HISTORIC
STARKVILLE
MISSISSIPPI'S COLLEGE TOWN
THE CITY OF STARKVILLE
DEVELOPMENT REVIEW COMMITTEE
CITY HALL, 101 E. LAMPKIN STREET
STARKVILLE, MISSISSIPPI 39759

SUBJECT: Starkville Tree Advisory Board
DATE/TIME/PLACE: MAY 6, 2015, 11:00 AM, CITY HALL CONFERENCE ROOM

TO: Members of the Tree Advisory Board
FROM: Daniel Havelin (662-323-2525 ext. 136)
SUBJECT: LW 15-02 Ergon Properties, Landscape Waiver, Mercantile Street, Zoned T6, Ward 4, Seeking relief from the requirement to have 1 canopy tree per landscape island, Applicant/ Owner: Ergon Properties, Inc./ Jim Defoe
DATE: May 6, 2015

TO: Members of the Tree Advisory Board
FROM: Daniel Havelin (662-323-2525 ext. 136)
SUBJECT: LW 15-03 Starkville Apartments LLC, Landscape Waiver, Southeast corner of Russell Street and Spring Street, Zoned T-5, Ward 4, Seeking relief from the requirement for landscaped perimeter of parking area, Applicant: Christian Preus Landscape Architecture, PLLC, Owner: Starkville Apartments, LLC
DATE: May 6, 2015

Attachment 3

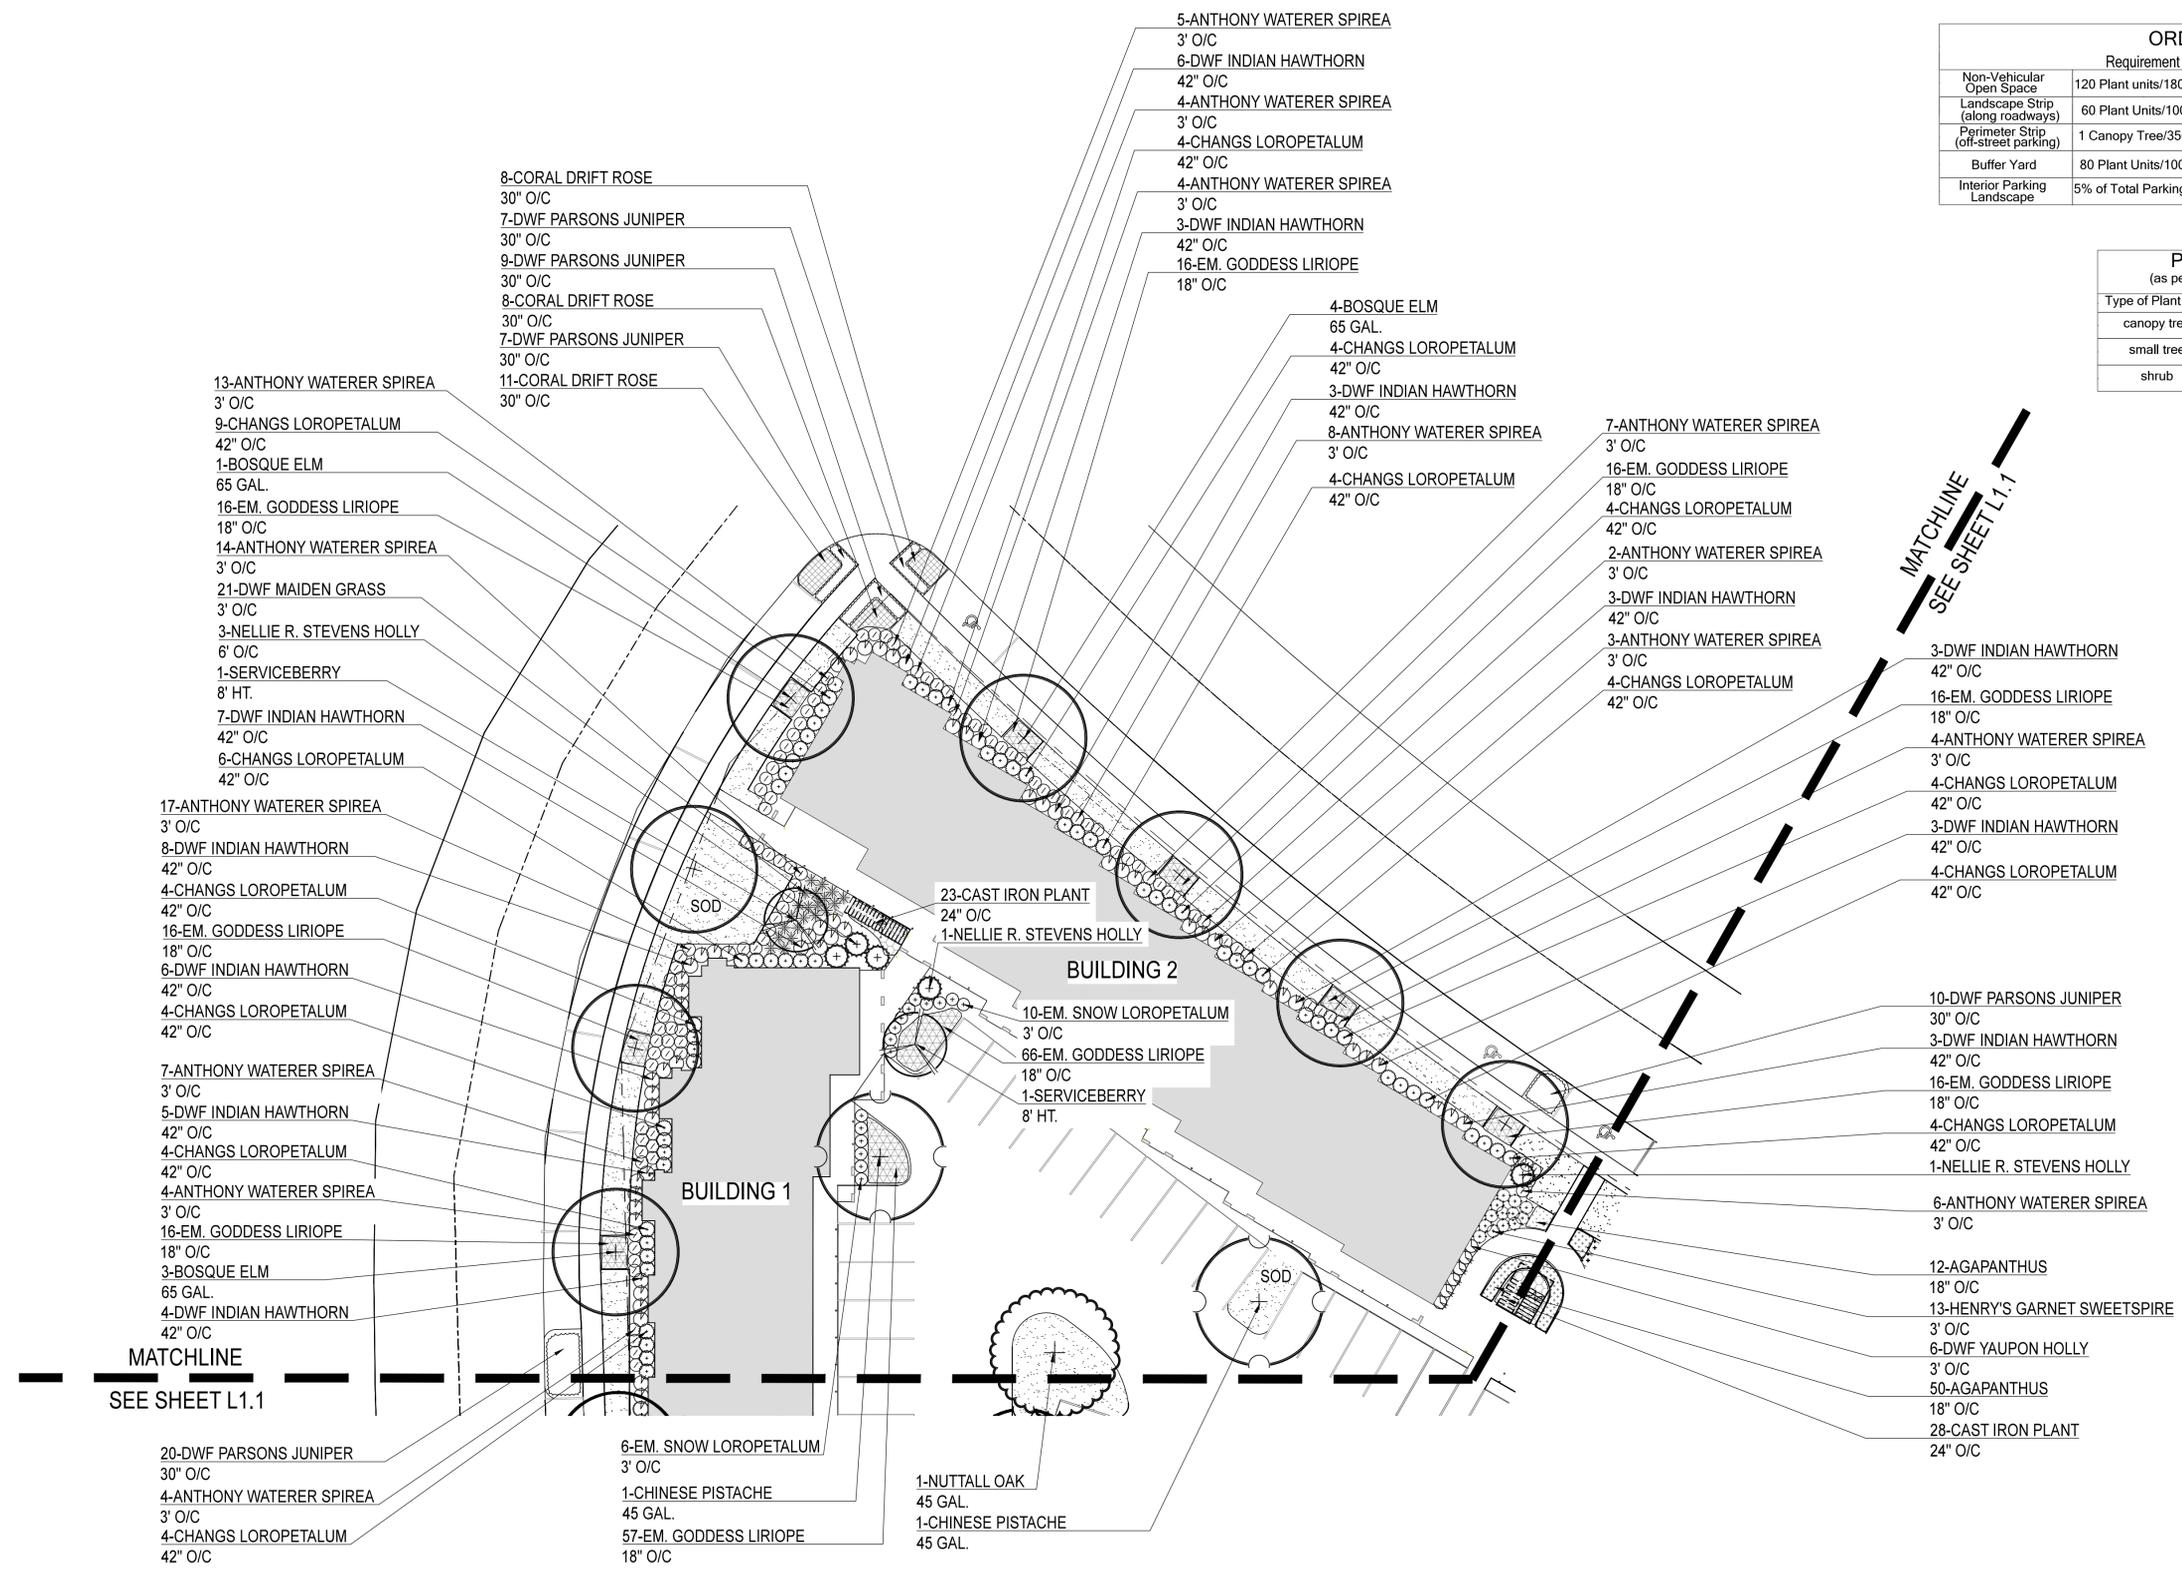
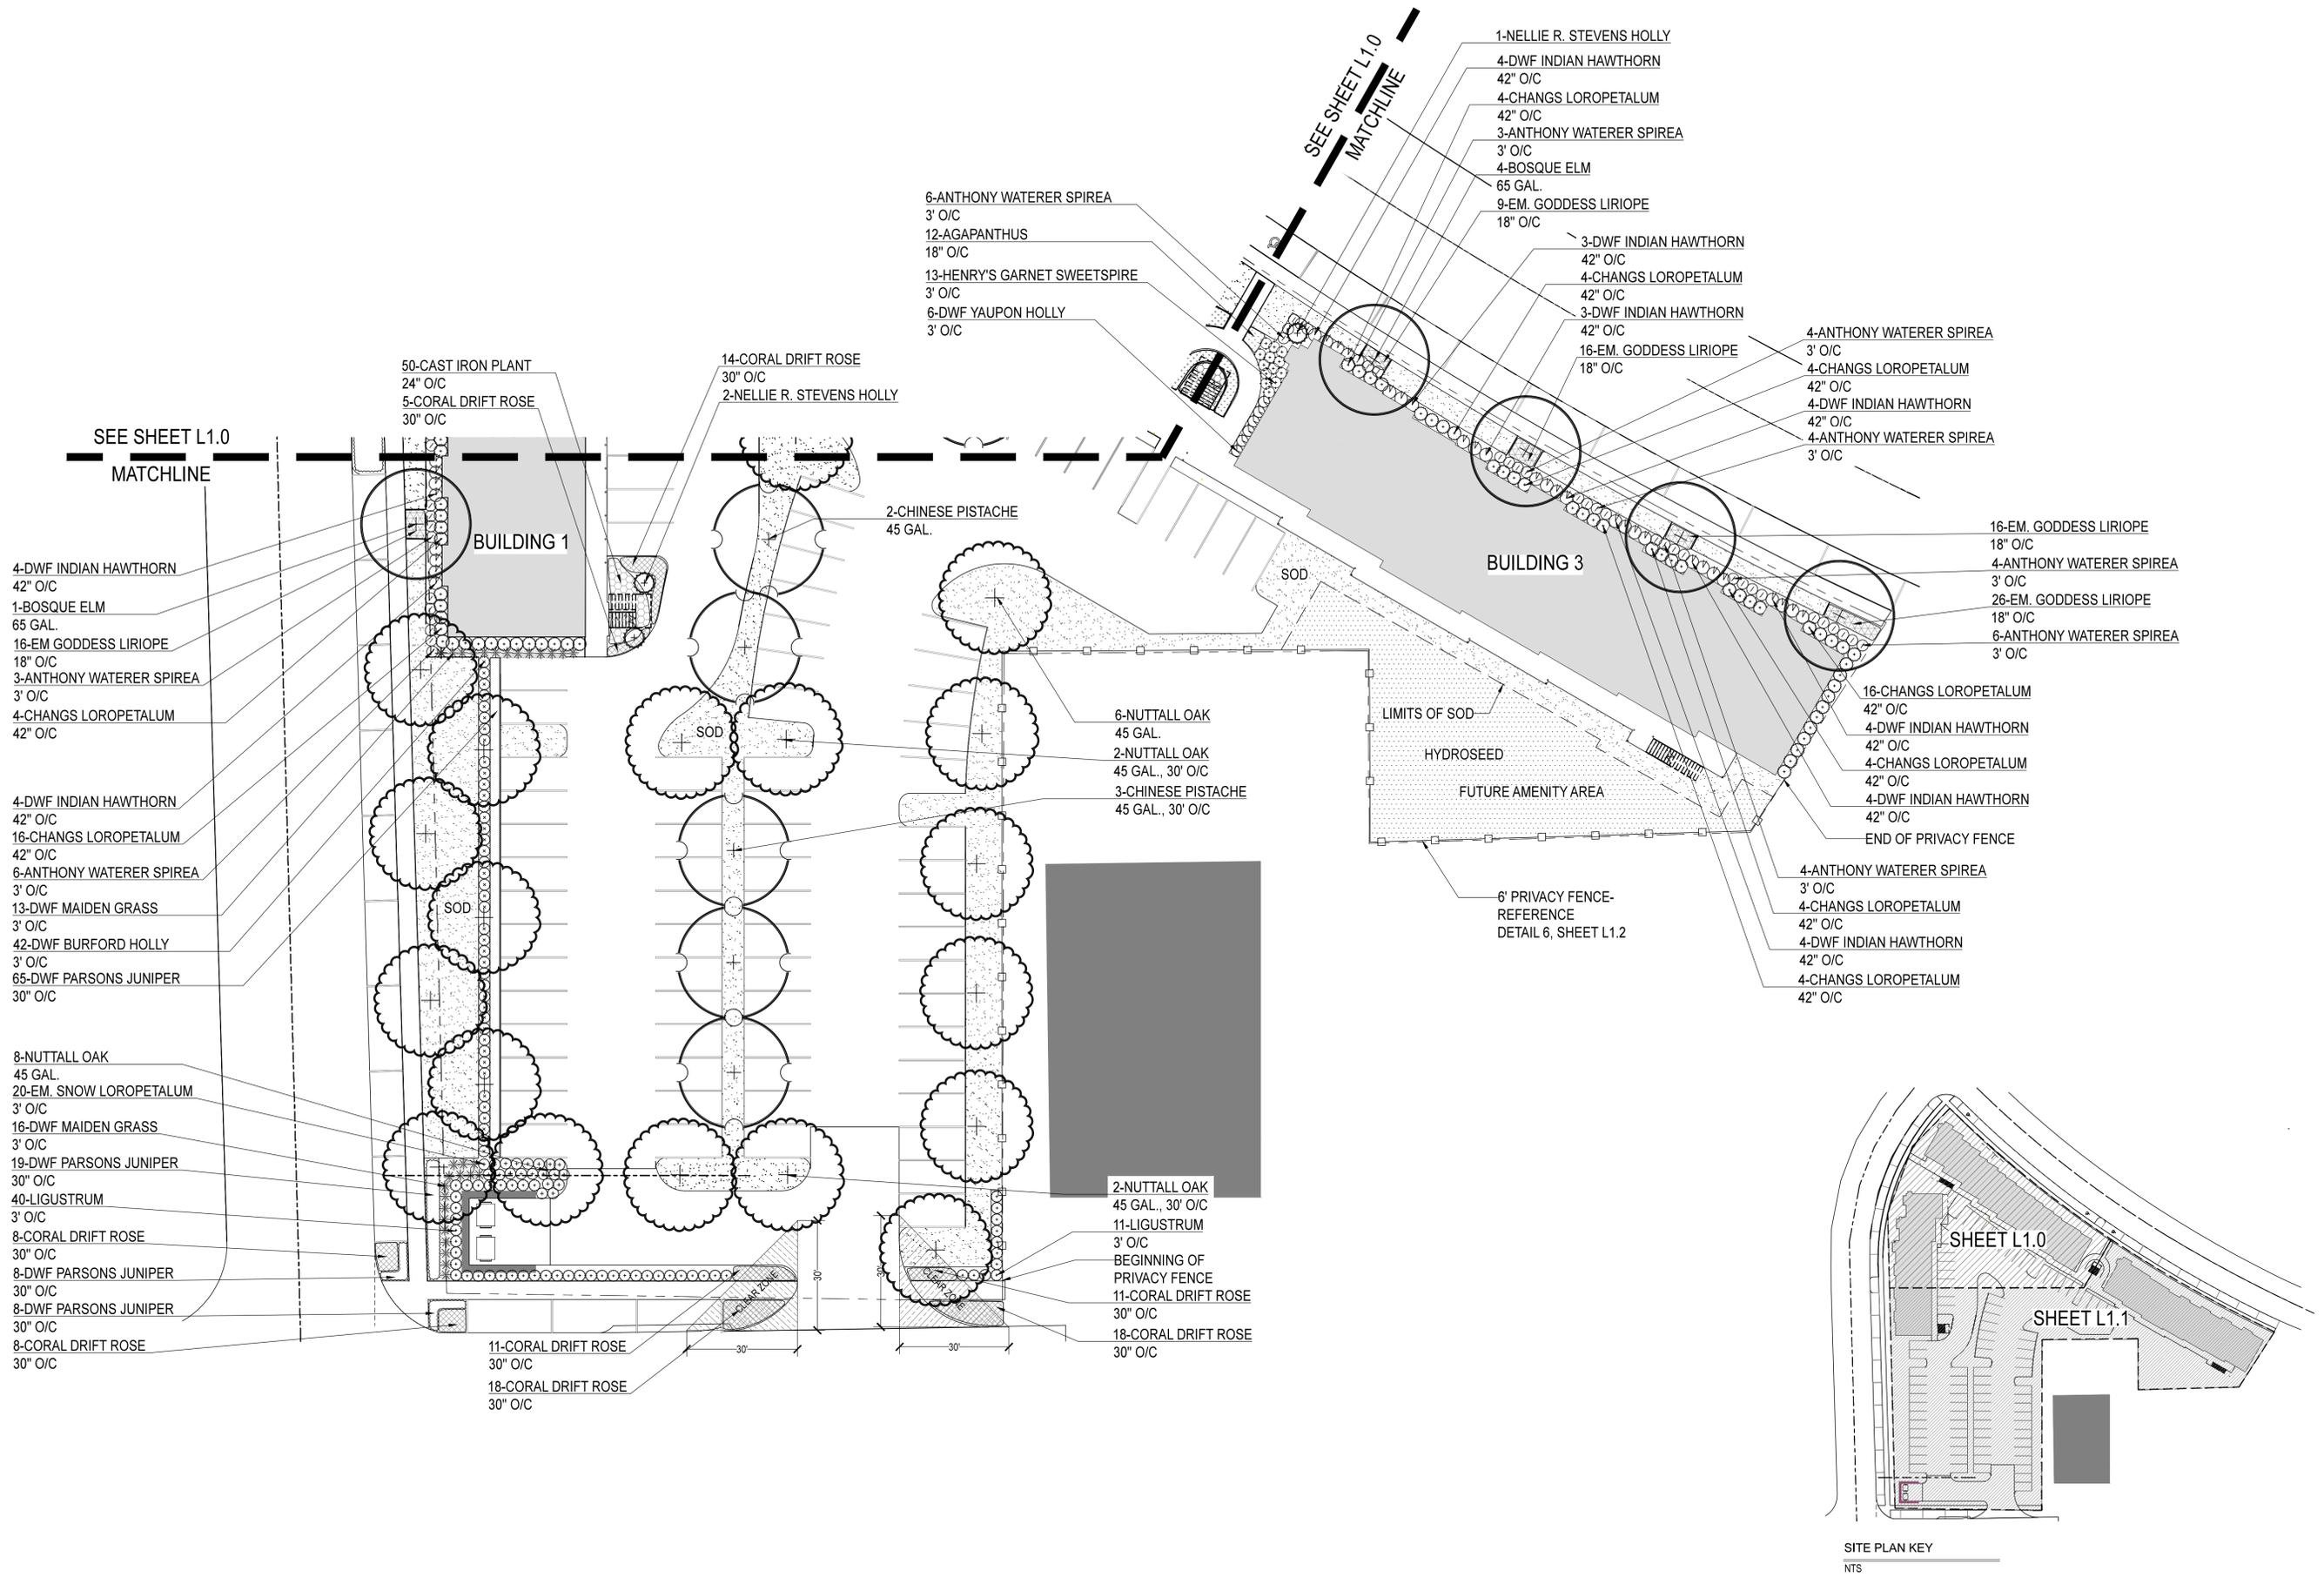
Starkville Apartments LLC is proposing to build an apartment development at the southeast corner of Russell Street and Spring Street. This site is approximately +/- 1.86 acre and is zoned T-5. The applicant is proposing to park the site on the south side of the property. The applicant is seeking relief on the perimeter parking requirements of planting shrubs along the edge of the parking lot. In lieu of shrubs, the applicant would like to use a fencing and sod. The dimensional requirement of the perimeter area would meet the current ordinance as would the canopy tree requirement. The applicant has expressed the desire to plant the front of the building in lieu of this requirement.

- According to Section 6 – Part B-1 a shrub screen with a height of 4 feet shall be continuous along perimeter of parking areas adjacent to property lines. Due to budget constraints and vehicular circulation requirements, relief is requested to allow a privacy fence in lieu of the required shrub screen.
- Note: Required Overall Site Plant Units are in compliance because the landscape emphasis was placed along the principal road frontages for community aesthetic value.

Attachment 3

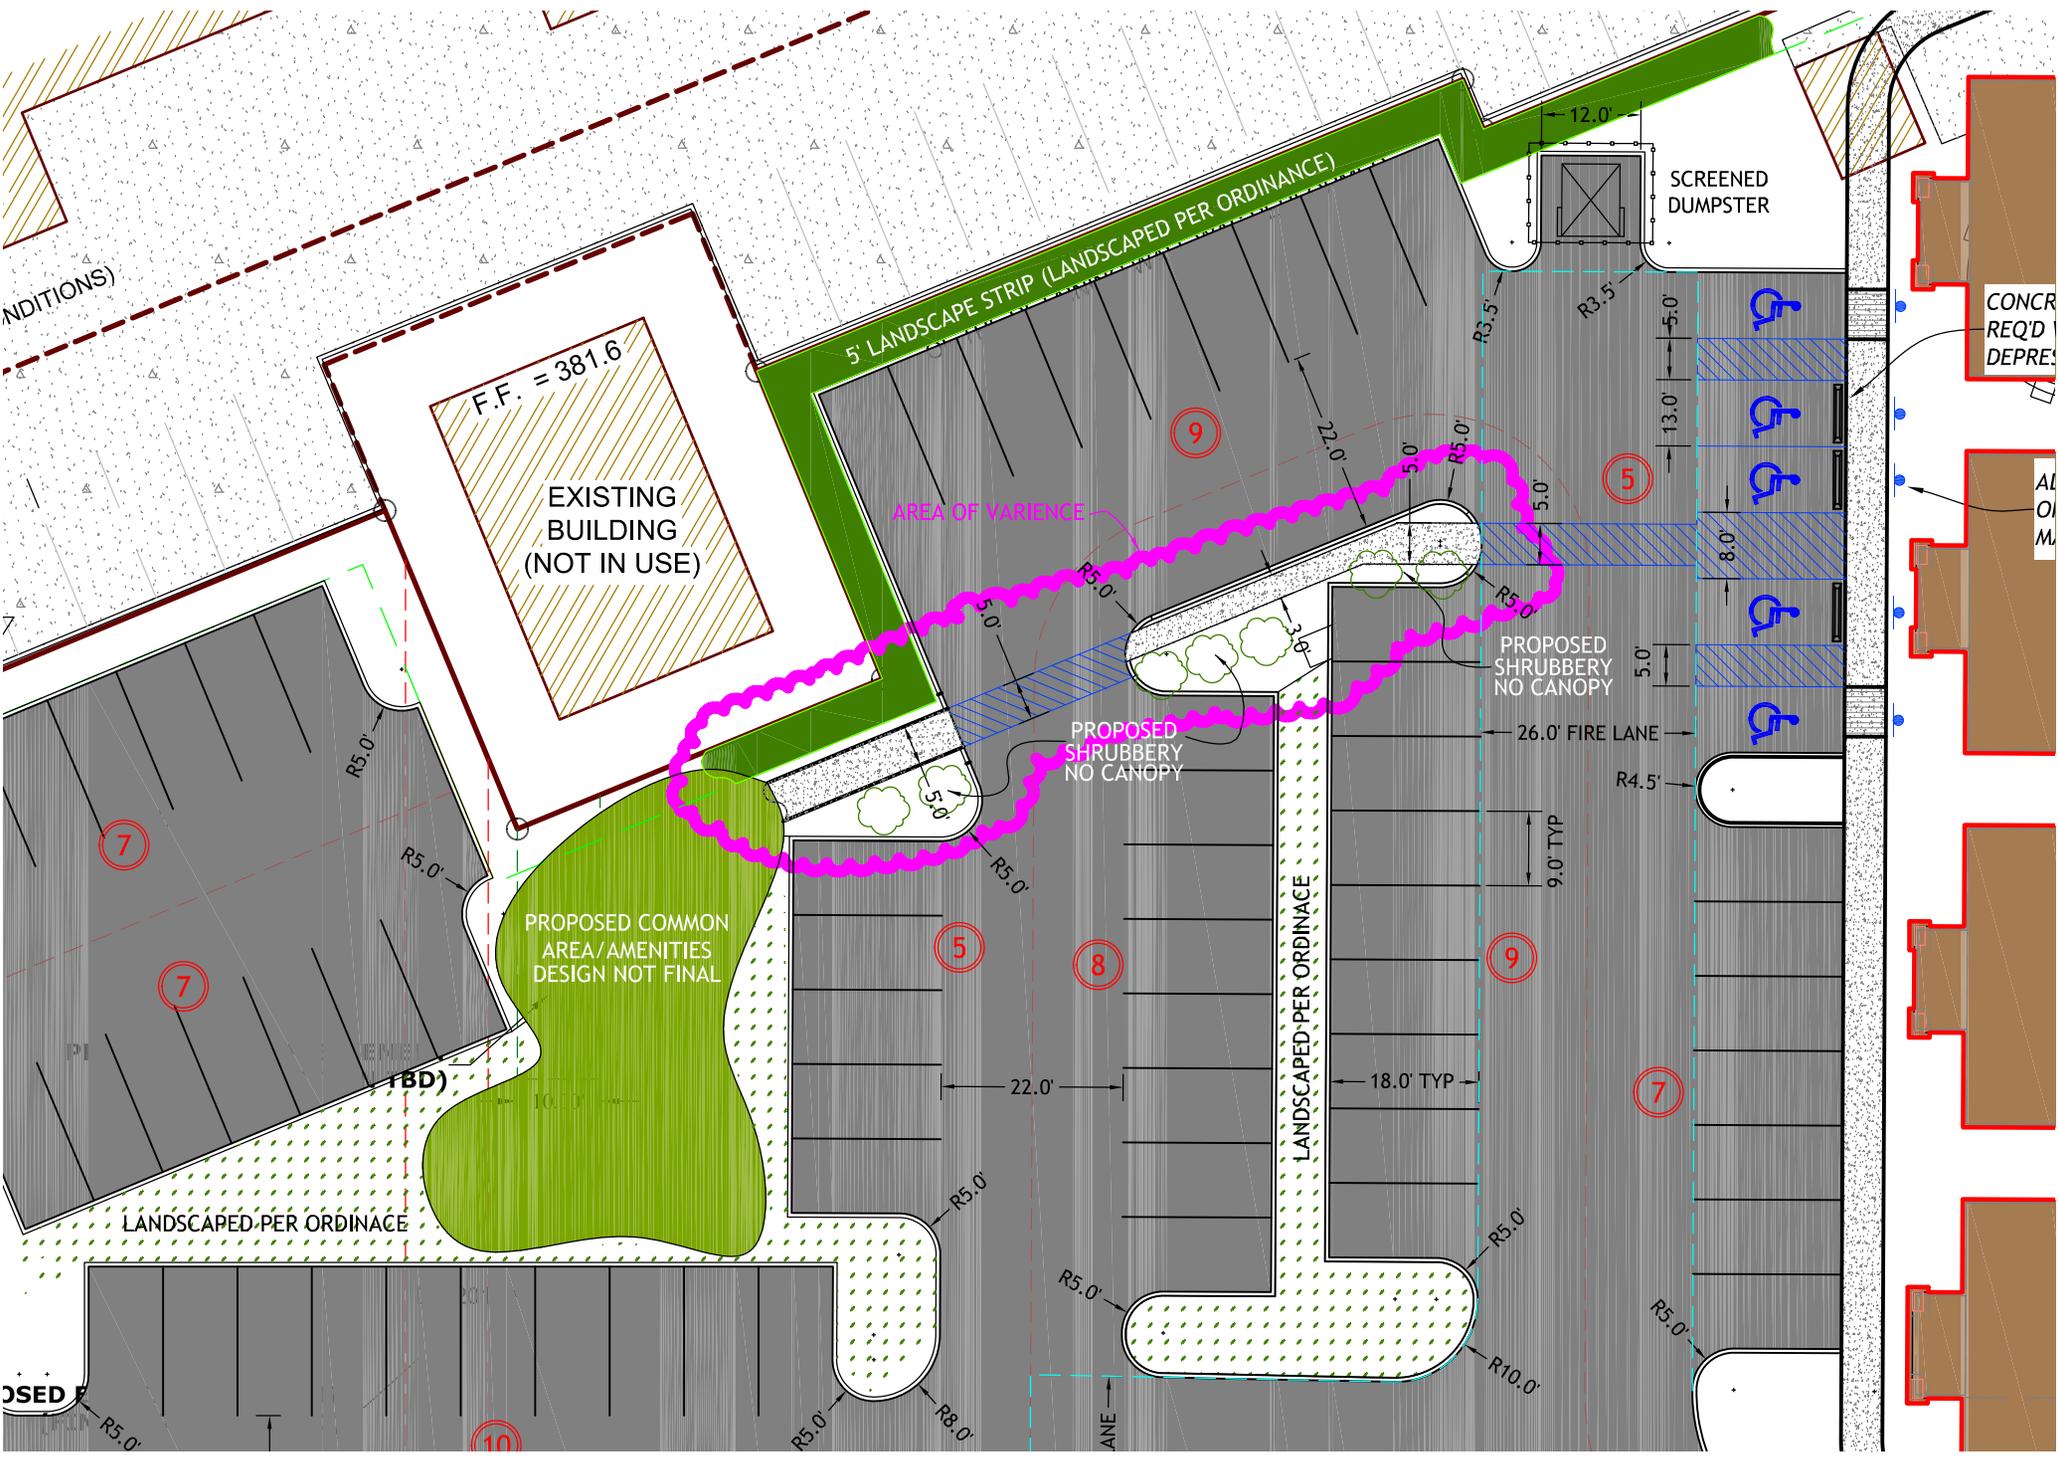
PLC Partners. LLC is proposing to build an apartment development on the parcel directly south of the Central Station development on South Montgomery. This site is approximately +/- 1.69 acre and is zoned T-5. The applicant is proposing to park the site on the western side of the property behind the proposed building. As currently design, they are proposing a common area in the middle of the parking lot. They are required to have an ADA path to the common area from the building. To accomplish this, they will need to use at least 3' of the parking lot island to cross the parking area. The applicant is seeking relief on the interior parking requirements of having a landscape island at the end of each row of parking.

- According to Part A of Section 6, all rows of parking of no more than 12 stalls must be separated by a landscaped area with a dimension of no less than that of a parking stall. With requirements of an ADA accessible route to the proposed amenity area, sidewalks will be required to pass through the north islands on one section of landscape area (See Attachment). We request relief of this ordinance in order to locate the required ADA path..
